RE: Legacy Apartments
6115 Alameda Blvd NE
Engineer's Stamp Date: 01/23/18
Hydrology File: C18D064B

PO Box 1293 Based upon the information provided in your resubmittal received 01/25/18, the Grading and Drainage Plan (revisions of the carport drainage only) is approved for Building Permit.

GRADING AND DRAINAGE PLAN

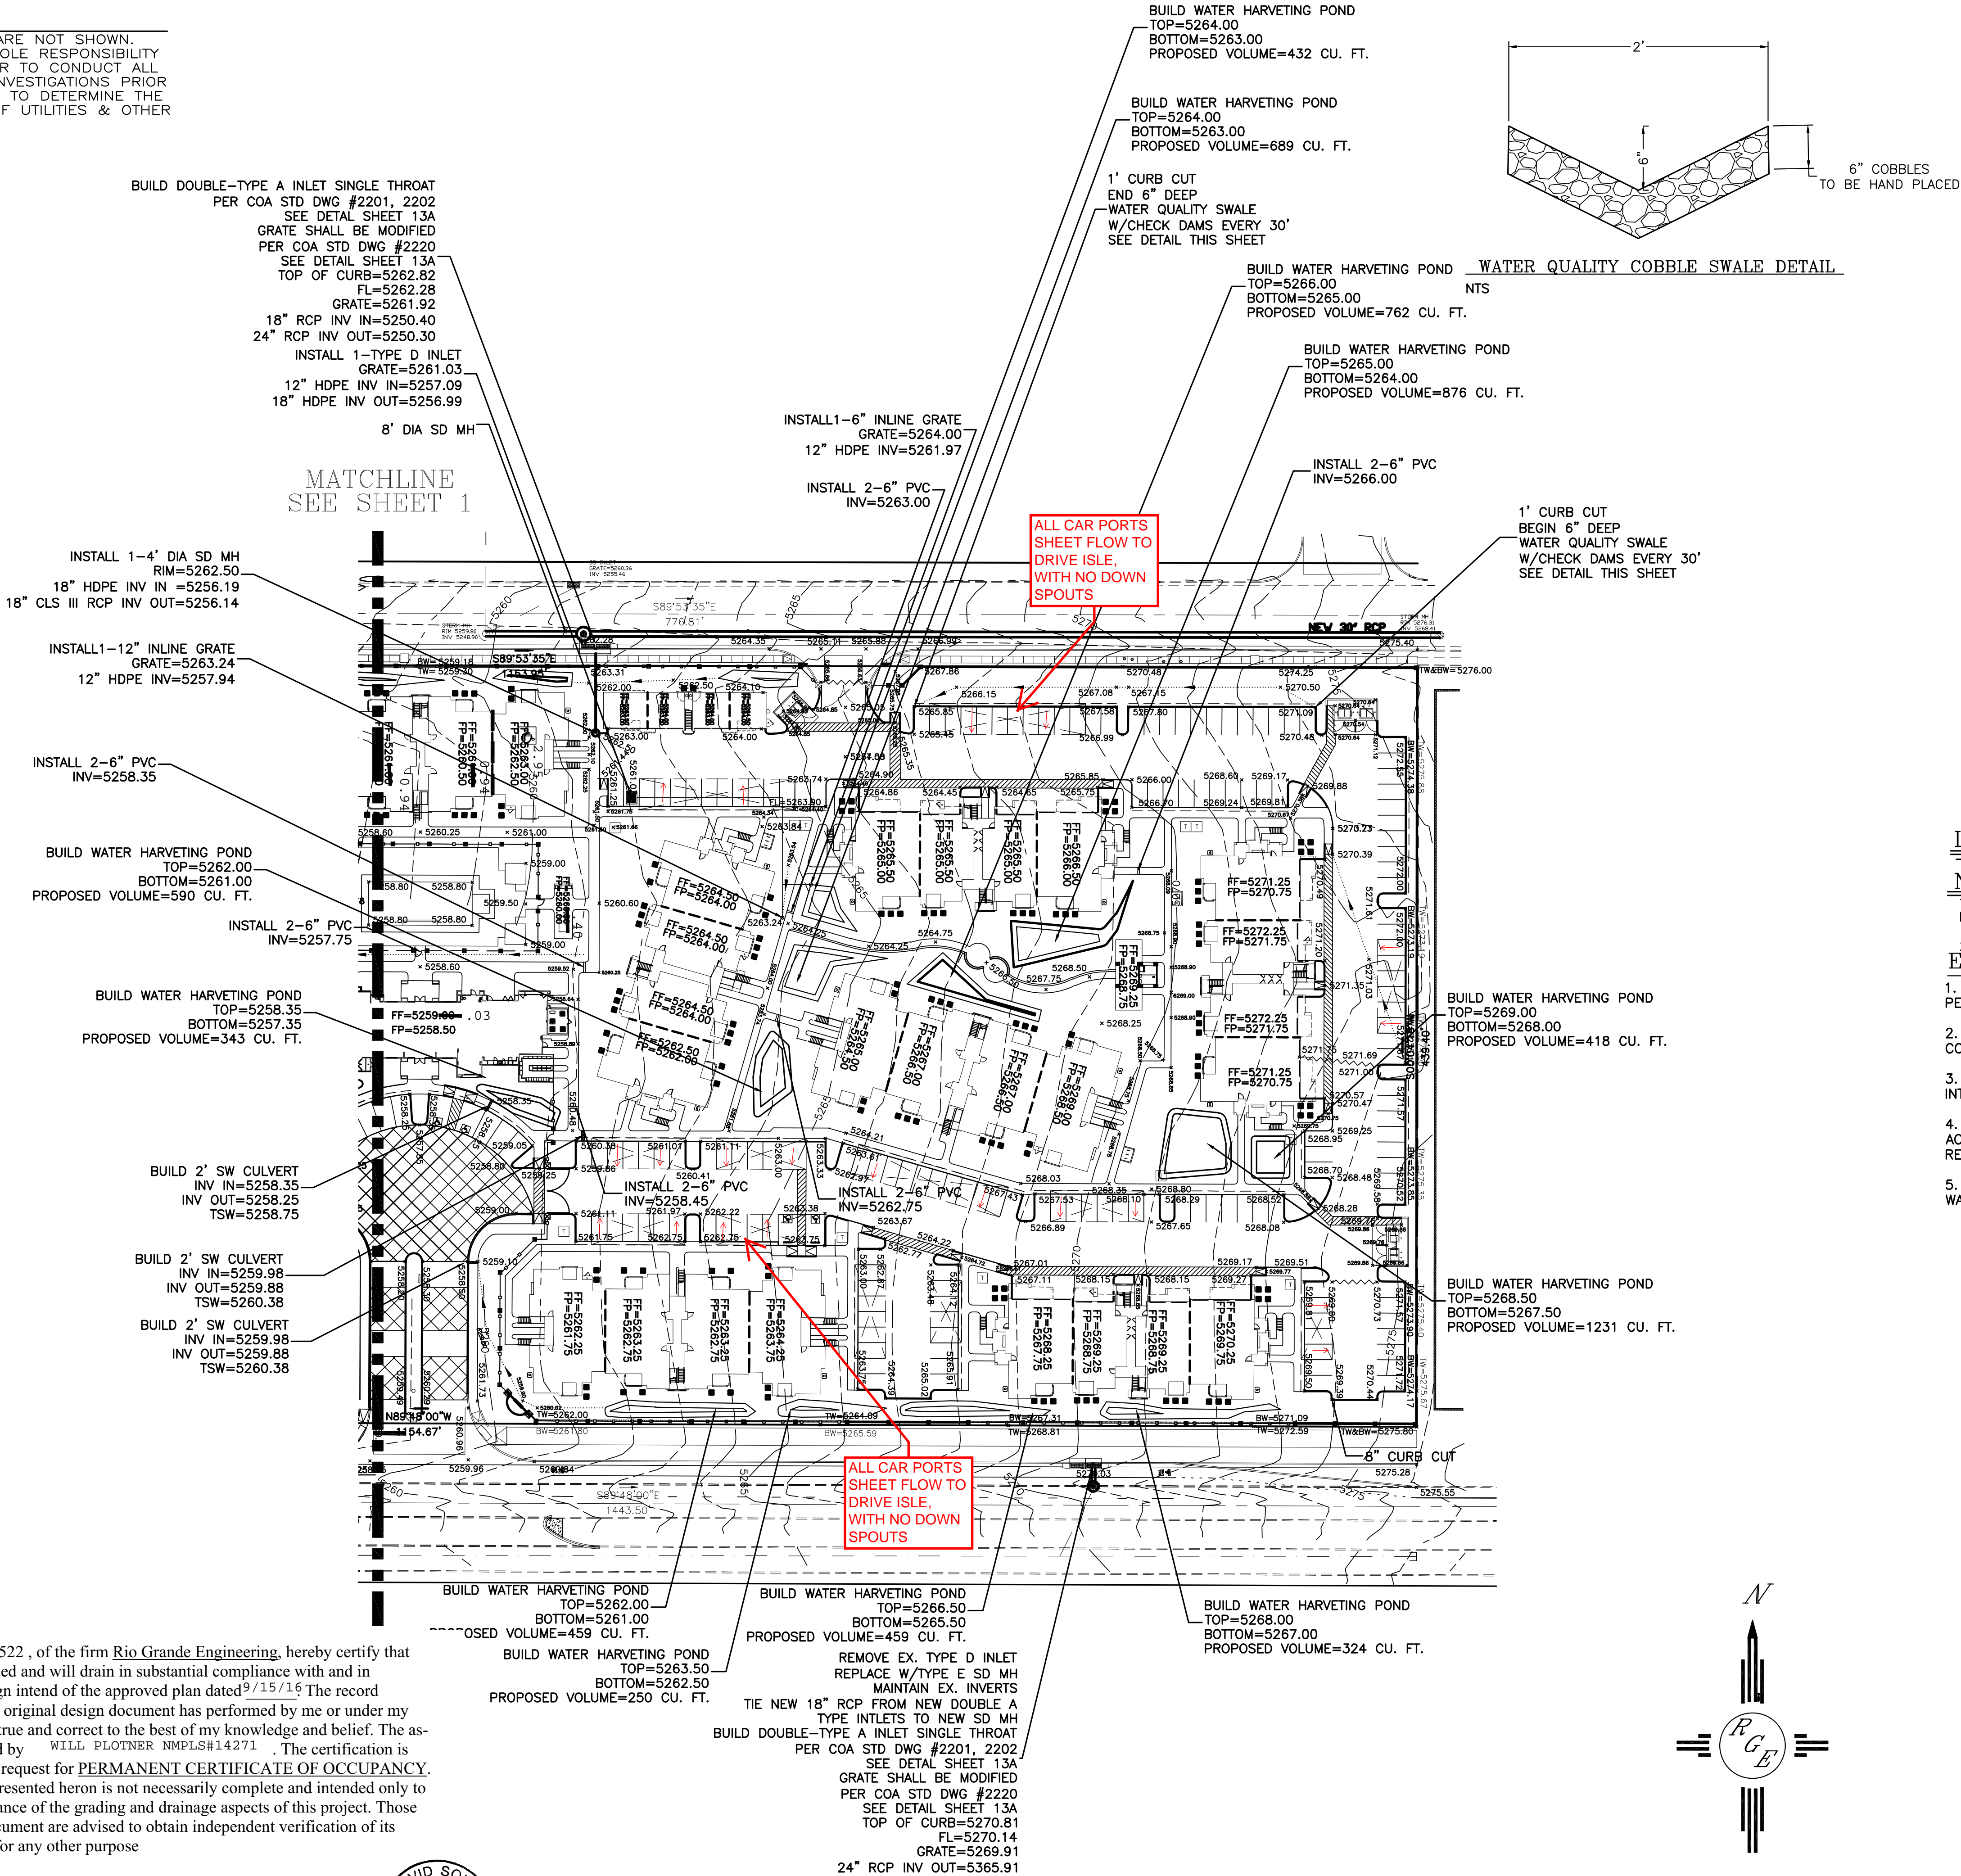
*** plan revised to show roof flow direction for carports only
